UNITED STATES PATENT AND TRADEMARK OFFICE

APPLICATION NO.	FILING DATE	FIRST NAMED INVENTOR	ATTORNEY DOCKET NO.	CONFIRMATION NO.
10/759,061	01/20/2004	Maurice Blanchette	16231-1US SC/sm	6678
20988	7590	12/29/2005		
OGILVY RENAULT LLP 1981 MCGILL COLLEGE AVENUE SUITE 1600 MONTREAL, QC H3A2Y3 CANADA				
EXAMINER GABLER, PHILIP FRANCIS				
ART UNIT		PAPER NUMBER		
3637

Office Action Summary	Application No. 10/759,061	Applicant(s) BLANCHETTE, MAURICE	
	Examiner Philip Gabler	Art Unit 3637

DETAILED ACTION

Exhibit 1: Mattick '484 Figures 1-3 and 5

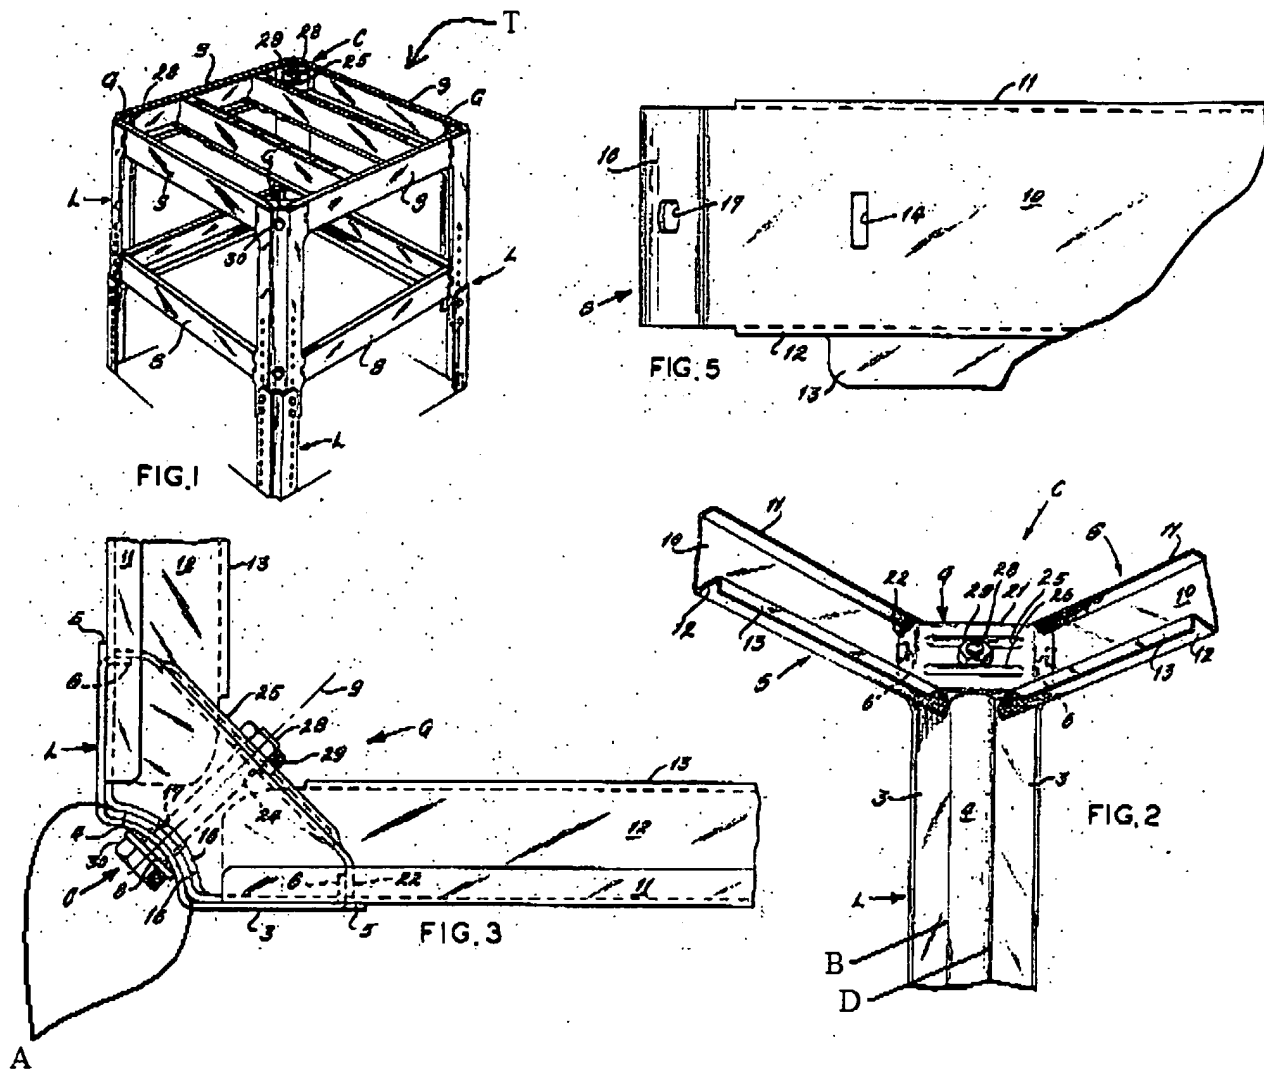
12. Claims 1-9 are rejected under 35 U.S.C. 102(b) as being anticipated by Mattick (US Patent Number 3420484). Mattick (Figures 1-3 and 5) discloses a platform assembly (T, Mattick's Figure 1) comprising a weldless frame (components S and L) including at least three profiles (S) bolted together so as to define a support plane, a support column (L) at each corner of said frame, said support column being bolted to said weldless frame. Note that the claim recites a product by process limitation ("cold-formed"). The product itself does not depend on the process of making it and this limitation would not be expected to impart distinctive structural characteristics to the device.

13. Regarding claim 2, Mattick further discloses profiles, which are beam members (S) of a predetermined cross-section. Note that this claim also recites a product by process limitation ("cut and folded"). The product itself does not depend on the process of making it and this limitation would not be expected to impart distinctive structural characteristics to the device. Therefore, Mattick's device is readable on applicant's device. In addition, it is inherent from Mattick's Figures 1-2 that his beam members were cut and folded into a predetermined cross section.

14. Regarding claim 3, Mattick further discloses profiles (S) that are C-shaped in cross section (see Figure 2) and wherein an open side of said profiles faces inwardly of said weldless frame.

15. Regarding claim 4, Mattick further discloses profiles (S) provided with connecting tabs (16) at opposed longitudinal ends thereof, each of said connecting tabs defining a

number of holes (14) and (17) for receiving fasteners in order to achieve mechanical connections between the profiles.

16. Regarding claim 5, Mattick further discloses connecting tabs that are folded at 90 degrees (indicated by A in Exhibit 1).

17. Regarding claim 6, Mattick further discloses support columns (L) with two open sides (opposite of sides 3).

18. Regarding claim 7, Mattick further discloses that the open sides face inwardly of said weldless frame (see Figure 2).

19. Regarding claim 8, as best understood, Mattick further discloses support columns with first and second longitudinally extending folds (B and D), said first and second folds having terminal longitudinal edge portion merging into flanges (6) oriented at about 90 degrees to respective extending portions.

20. Regarding claim 9, Mattick further discloses a corner brace (G) at each corner of said frame, each brace being bolted to adjacent profiles extending from the corner.

Shelton '348 Figures 1 and 7

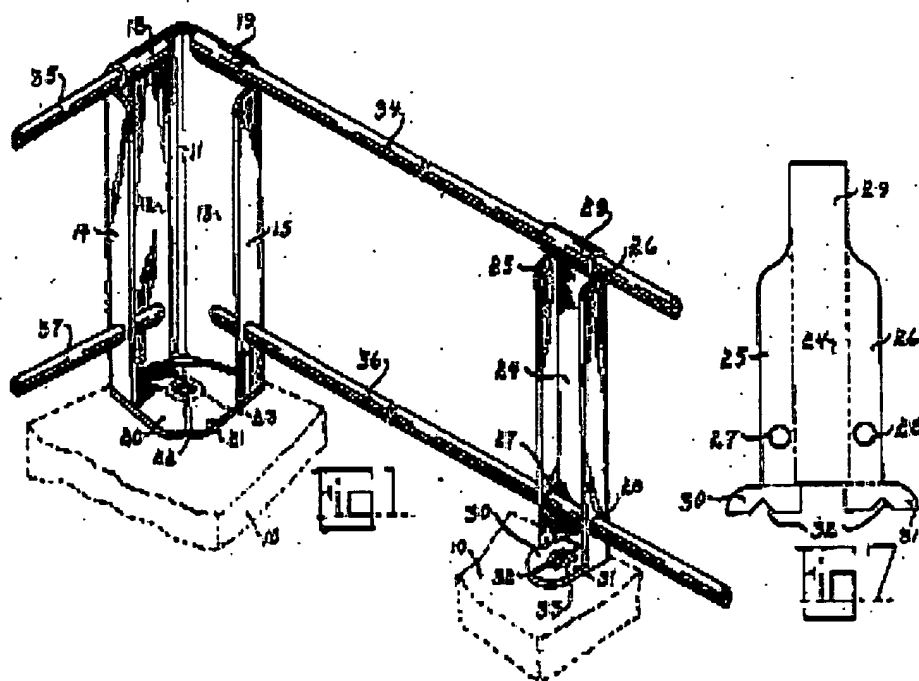
22. Claim 10 is rejected under 35 U.S.C. 103(a) as being unpatentable over Mattick in view of Shelton (US Patent Number 2238348). Mattick discloses a platform assembly as recited in claim 1 but does not disclose a guard rail projecting upwardly from the perimeter. Shelton discloses (Figures 1 and 7) a guard rail projecting upwardly from a portion of a surface (10), said guard rail including a number of guard rail posts (24), said guard rail post being made from C-shaped profiles. Note that this claim recites a product by process limitation ("cut and folded"). The product itself does not depend on the process of making it and this limitation would not be expected to impart distinctive structural characteristics to the device. Accordingly, it would have been obvious to one of ordinary skill in the art at the time the invention was made to modify Mattick's platform to include a guard rail assembly as taught by Shelton because this would keep objects from falling from the platform (see Shelton column 1 lines 50-51).

24. Regarding claim 12, Shelton further discloses a solid tubular rail (36) mounted in his receiving cavity. Note that this claim recites a product by process limitation ("welded"). The product itself does not depend on the process of making it and this

25. Regarding claim 13, Shelton further discloses a depression (29) defined at the top end of the guard rail post extending across said folds so as to define a seat for receiving a hand rail.

Diamond '897 Figures 2 and 4

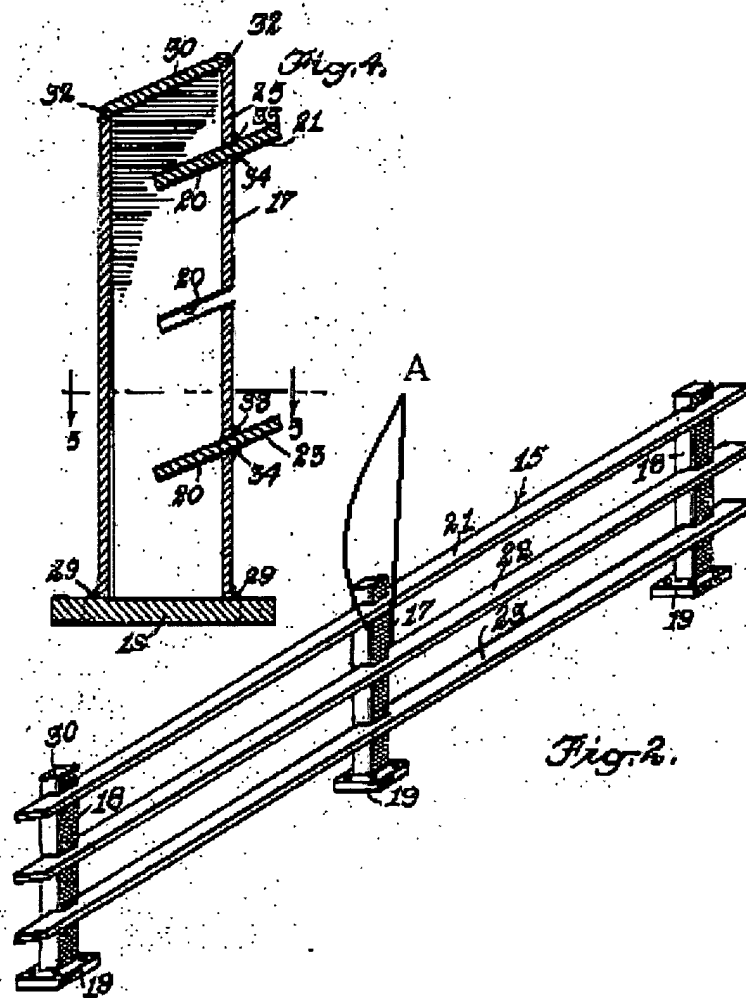
23. Claims 11-13 are rejected under 35 U.S.C. 103(a) as being unpatentable over Mattick in view of Shelton and further in view of Diamond (US Patent Number 2733897). Mattick, when modified by Shelton as described above, discloses a platform as recited in claim 10 but does not disclose a hole extending through fold lines defining a receiving cavity. Diamond (Figures 2 and 4) discloses a guard rail post having two parallel longitudinal folds (viewed as A in Exhibit 2) and wherein an oblong hole (20) extends transversely through said folds to define a rail receiving cavity on a back side of the post. Accordingly, it would have been obvious to one of ordinary skill in the art at the time the invention was made to modify Mattick's platform, previously modified by

Shelton, to include an oblong hole through the post (by simply connecting Shelton's holes 27 and 28) to receive a rail as taught by Diamond because this arrangement would provide a simpler method of mounting rails to the guard rail post.
